**BEFORE THE PUBLIC UTILITY COMMISSION  
OF OREGON**

LC 77

2021 Integrated Resource Plan.

**DISPOSITION: 2021 IRP ACKNOWLEDGED WITH MODIFICATIONS AND  
EXCEPTIONS**

**Figure 1: 2020 Coal Fuel and Production Expenses**

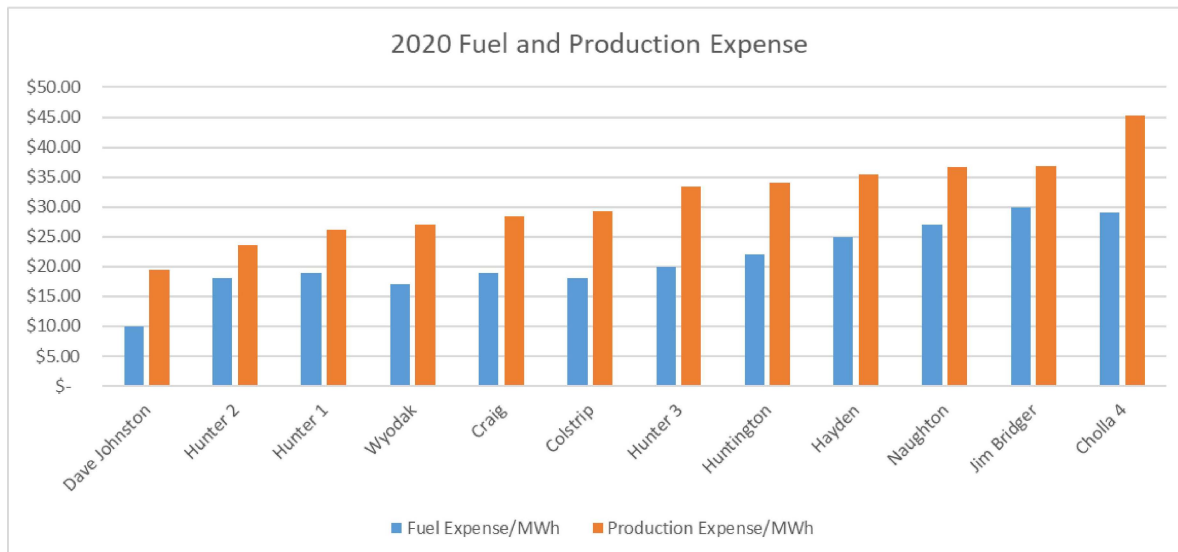
Staff has been skeptical of Jim Bridger 3 and 4 remaining in the IRP preferred portfolio through 2037 in part because of the units’ high variable costs. Staff would like to further discuss variable costs at this time, as well as the fixed costs of keeping the plant online to provide flexible capacity. While the high variable costs at these units make the plants expensive from an energy perspective, the high nameplate capacity of the plant (about 2,300 MW in total and about 1,425 MW owned by PacifiCorp) help to distribute any fixed costs over a higher number of MW of capacity.

FERC Form 1 data from 2020 shows that Jim Bridger units had the highest fuel and production expenses of any coal units on PacifiCorp’s system in 2020.<sup>25</sup> This is part of why the inclusion of Jim Bridger 3 and 4 as coal units through 2037 has been surprising.
